1. Type of Well <input checked="" type="checkbox"/> Oil Well <input type="checkbox"/> Gas Well <input type="checkbox"/> Other		8. Well Name and No. POKER LAKE UNIT 100
2. Name of Operator XTO PERMIAN OPERATING LLC Contact: TRACIE J CHERRY E-Mail: tracie_cherry@xtoenergy.com		9. API Well No. 30-015-27961-00-S1
3a. Address 6401 HOLIDAY HILL ROAD BLDG 5 MIDLAND, TX 79707	3b. Phone No. (include area code) Ph: 432-221-7379	10. Field and Pool or Exploratory Area POKER LAKE
4. Location of Well (Footage, Sec., T., R., M., or Survey Description) Sec 24 T24S R30E SWSE 660FSL 1980FEL		11. County or Parish, State EDDY COUNTY, NM

Poker Lake Unit #100

30-015-27961

Intent to P&A

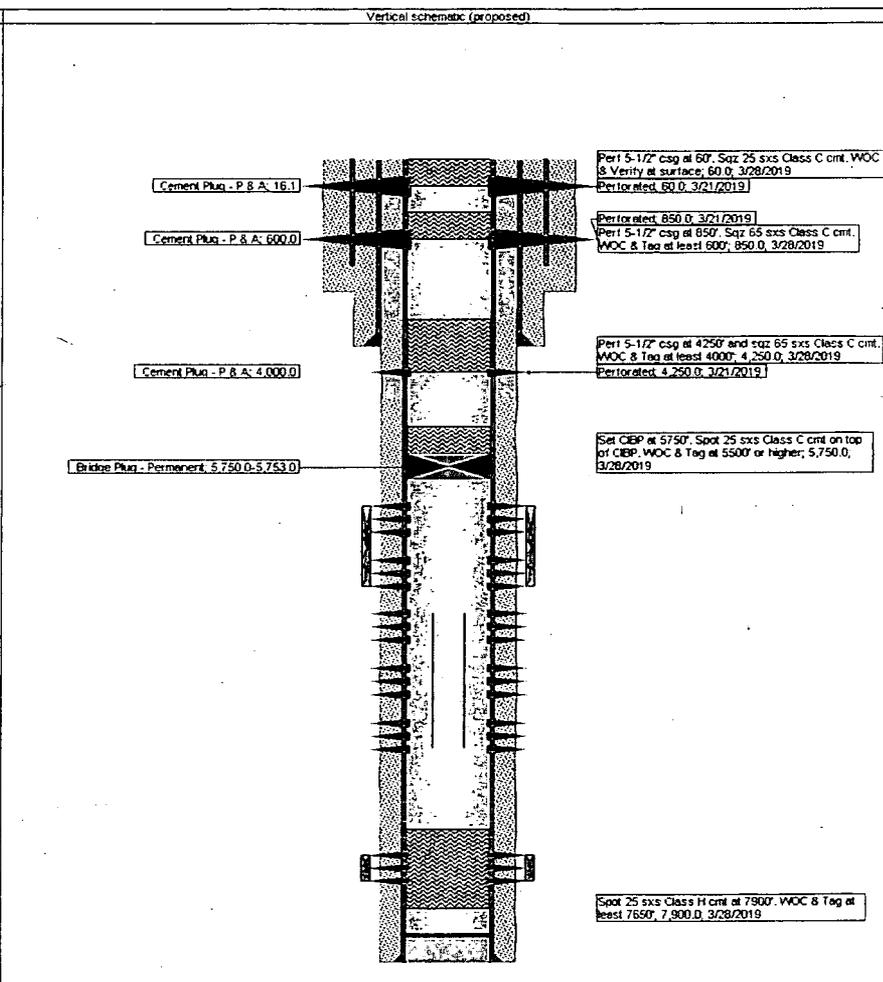
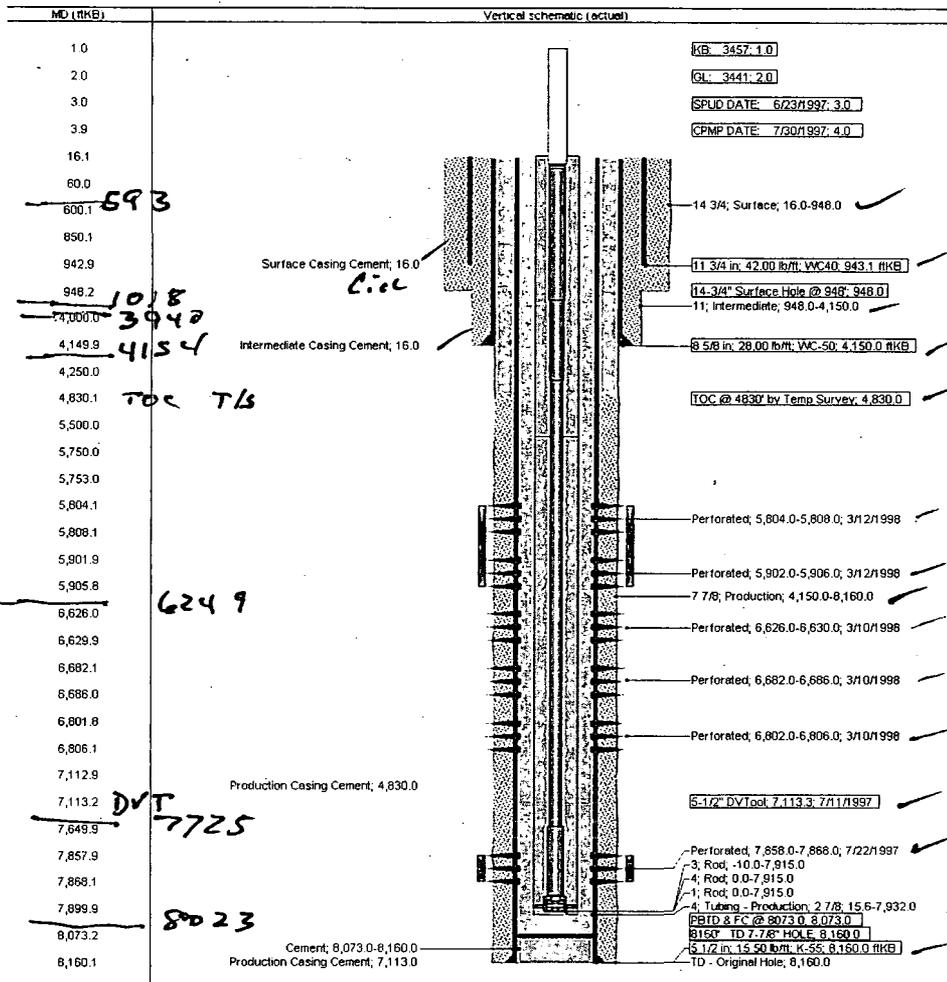
- MIRU. POOH with rods and pump. Remove wellhead and install 3K manual BOP. Function test.
- RIH w/tbg and tag PBSD @ 8073'. PUH and spot 25 sxs Class H cmt 7900' - 7650'. WOC and tag.
- Set 5-1/2" CIBP @ 5750'. Tag w/tbg to verify setting. Spot 25 sxs Class C cmt on top. WOC & tag. Circulate 9.5# salt gel mud. Test casing to 500 psi
- Perf 5-1/2" csg @ 4250'. Sqz 100 sx Class C to 4000'. WOC & tag. (csg shoe). (Base Salt)

5. Perf 5-1/2" csg @ ¹⁰⁶⁸850'. Sqz 65 sxs Class C to ⁸⁹³600' WOC & tag (T/Salt). (Shoe)
6. Perf 5-1/2" @ 60'. Sqz 25 sxs Class C to surface. WOC & verify cmt to surf.

** BLM REVISED **
